**ADDENDUM 2  
TO THE CONTRACT PROVISIONS AND CONTRACT PLANS**

**NORTHSHORE UTILITY DISTRICT  
BUILDING "A" IMPROVEMENTS**

**G&O #18601**

**ISSUED THIS DATE: THURSDAY, MARCH 23, 2023**

**INVENTORY ROOM  
LAMINATED CEILING PANEL DETAIL**

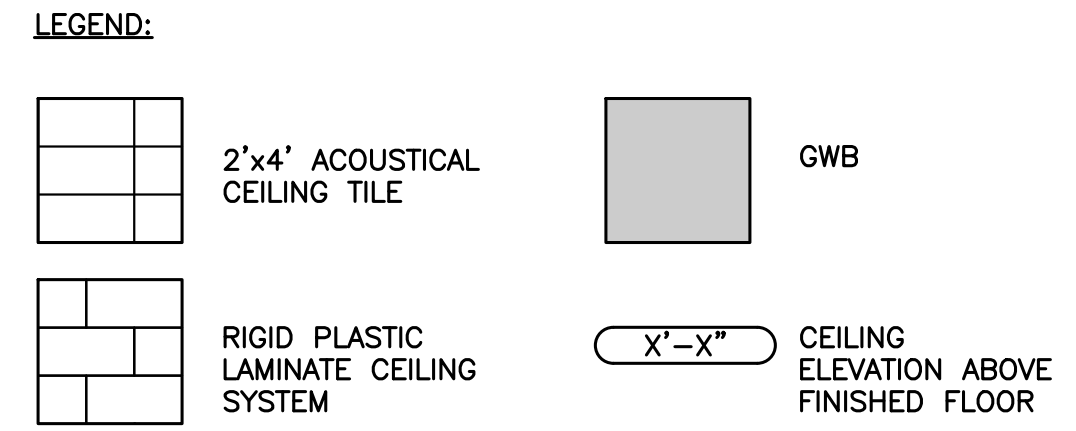
**ADD** the attached Inventory Room Laminated Ceiling Panel Detail to this Sheet.

**NOTE:**

1. NEW CEILING PANEL SYSTEM SHALL BE NOTCHED AND FIT AROUND EXISTING UTILITIES THAT ARE WITHIN THE PLANE OF THE CEILING.

**REVISION TO TYPICAL SEISMIC  
 PIPE SUPPORT DETAIL**

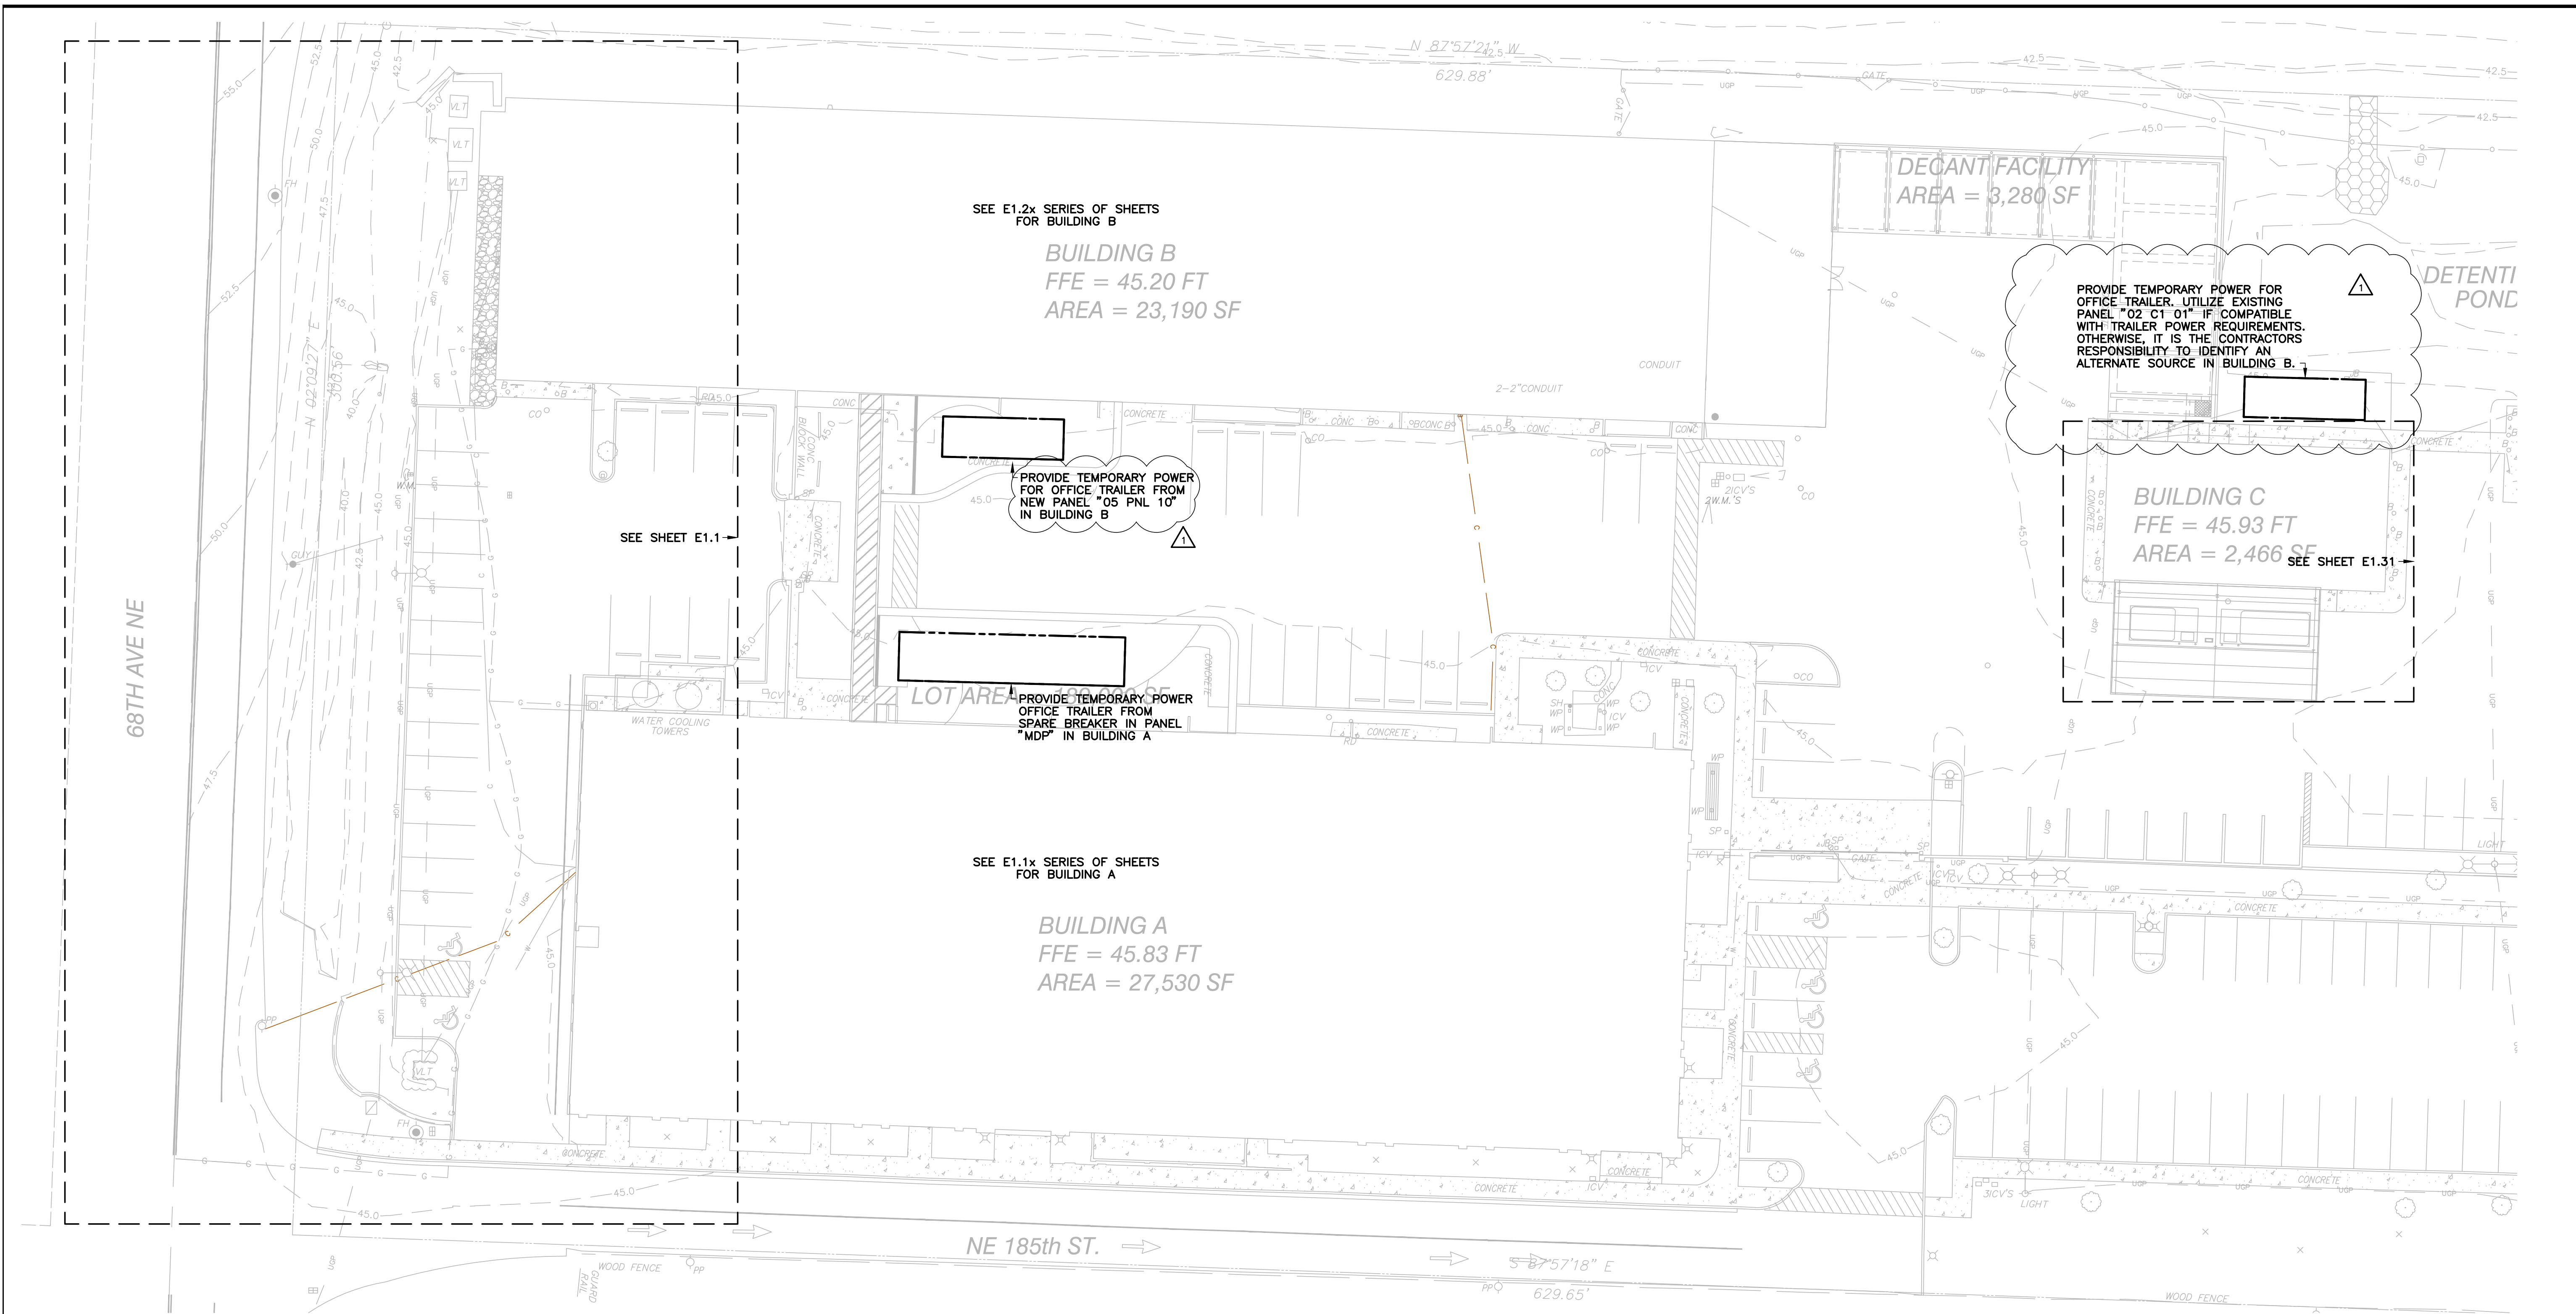
**REPLACE** the Detail 1 – Typical Seismic Pipe Support with the attached revised Detail 1 – Typical Seismic Pipe Support.

BUILDING A CENTRAL LIGHTING PLAN  
SCALE: 3/16" = 1'-0"

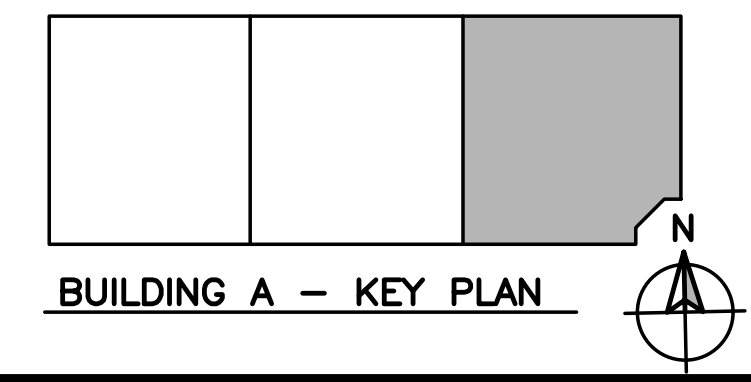
**ADD** general note C as follows:

- “C. UTILIZE THE EXISTING ROOM LIGHTING BRANCH CIRCUITS FOR NEW LIGHT FIXTURES. EXISTING LIGHTING BRANCH CIRCUITS, WHERE IDENTIFIED, ARE BASED ON AVAILABLE RECORD DRAWING AND HAVE NOT BEEN FIELD VERIFIED. THE CONTRACTOR SHALL FIELD VERIFY LIGHTING BRANCH CIRCUITS IN ALL AREAS WITH LIGHTING REVISIONS IN THE PROJECT. THE CONTRACTOR SHALL NOTIFY THE OWNER/ENGINEER WHERE EXISTING CIRCUITS ARE INCOMPATIBLE WITH THE DESIGN INTENT DEPICTED ON THIS SHEET AND SHEET E-6.5 PRIOR TO BEGINNING INSTALLATION.”
